Camping provision in the National Park and the Loch Achray campsite

The main flaws in the proposed Loch Achray campsite

CAMPING PITCH DESIGN

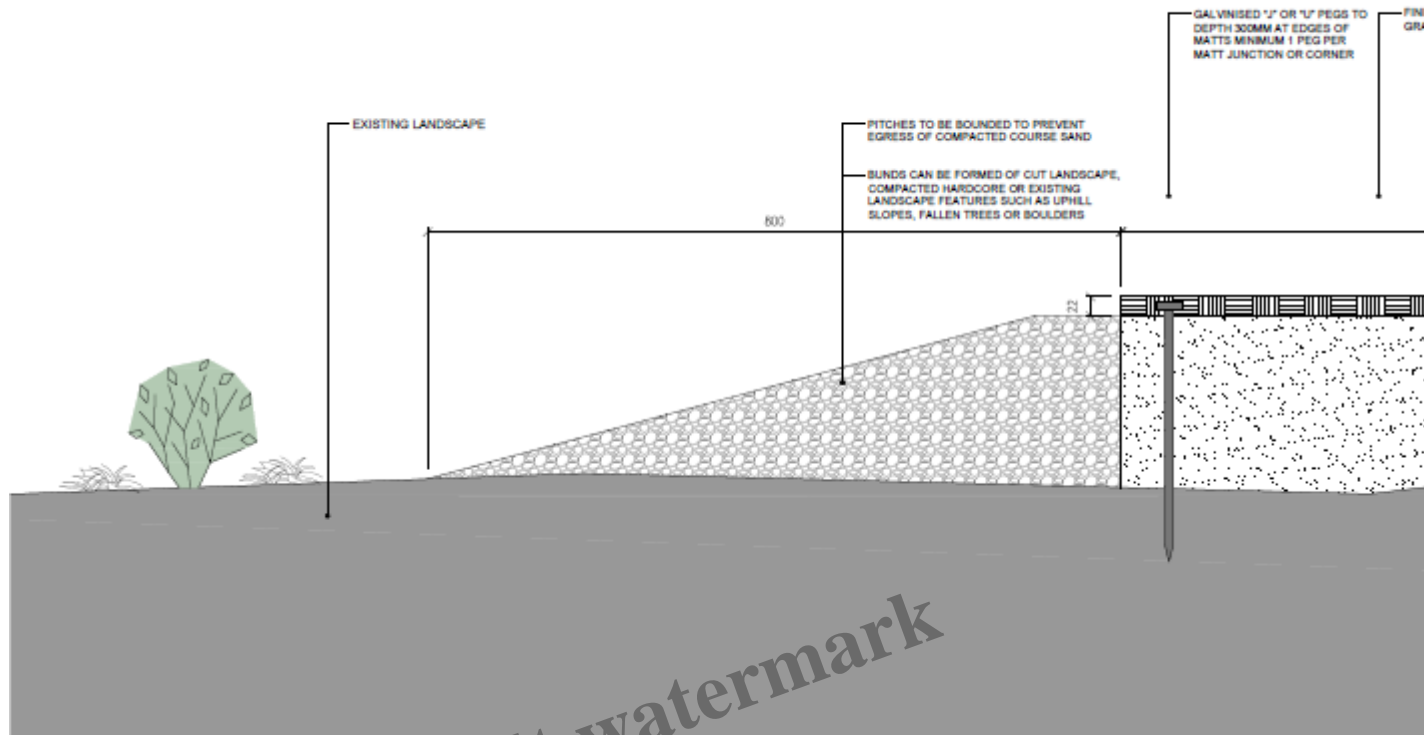
Camping on bark is horrible and describing it as traditional is simply "parkspeak". However, it appears that the current proposal is for rubber pitches on raised sand beds:

No-one from the Park appears to have asked any campers whether they like camping on artificial mats – although I guess if people were asked they might suggest their use on some of the sloping pebble beaches which the Park has designated as camping permit areas!

Just why the National Park is wanting to create 9 artificial places on this beautiful grassy area where people have been camping for over 30 years is not explained.

The creation of fixed pitches here is control freakery. It appears the Park cannot bear the thought of people being able to choose where they camp, picking a suitable spot according to the conditions. This is contrary to the spirit of freedom to roam. While the Park has said it wishes to develop basic campsites that promote the wild camping experience, paradoxically it appears it cannot abide anything basic and feels compelled to adopt suburban solutions for a National Park whose fundamental purpose is to enable people to enjoy nature.

While some work might be required to create the 3 camping pitches on the west side of the burn, where the land is boggy and overgrown, this could be done without rubber matting. NO artificial pitches are needed in the largest camping area on the east side of burn.

2.3 Off Site Management / Resources

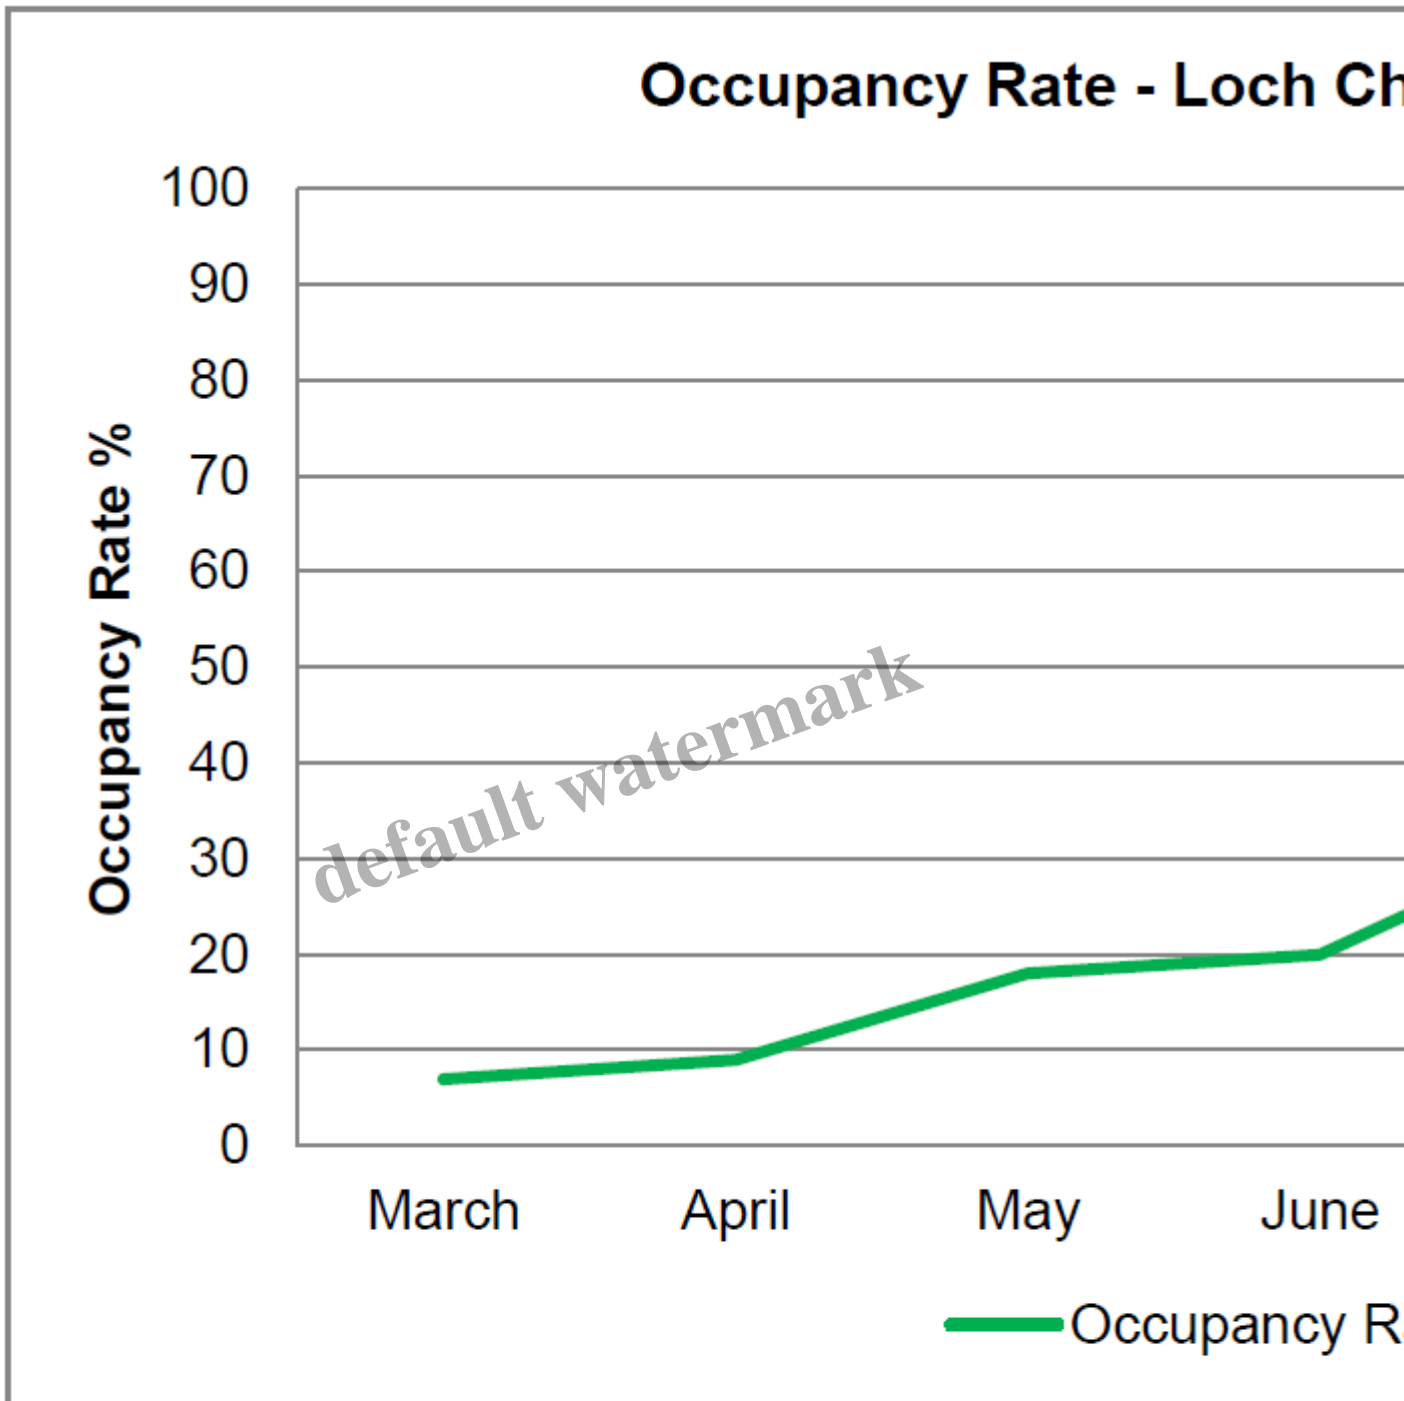
This is madness which appears driven by the need to get SEPA to withdraw their objection. The Loch Achray site is actually much better and safer for camping than some of the camping permit areas created by the Park which are regularly underwater and unusable (e.g the beaches at Firkin Point). The difference though is the permit areas never required planning permission. More hypocrisy from the LITNPA and other agencies. Should SEPA not have been objecting to many of the permit areas because of their flood risk?

The cost implications of this staffing are significant. 10 hours at even £10 per hour (minimum wage plus on costs) is £100 a day. 17 places are planning and lets the campsite does twice as well as Loch Chon, which was always too big and is more remote and whose occupancy is as follows:
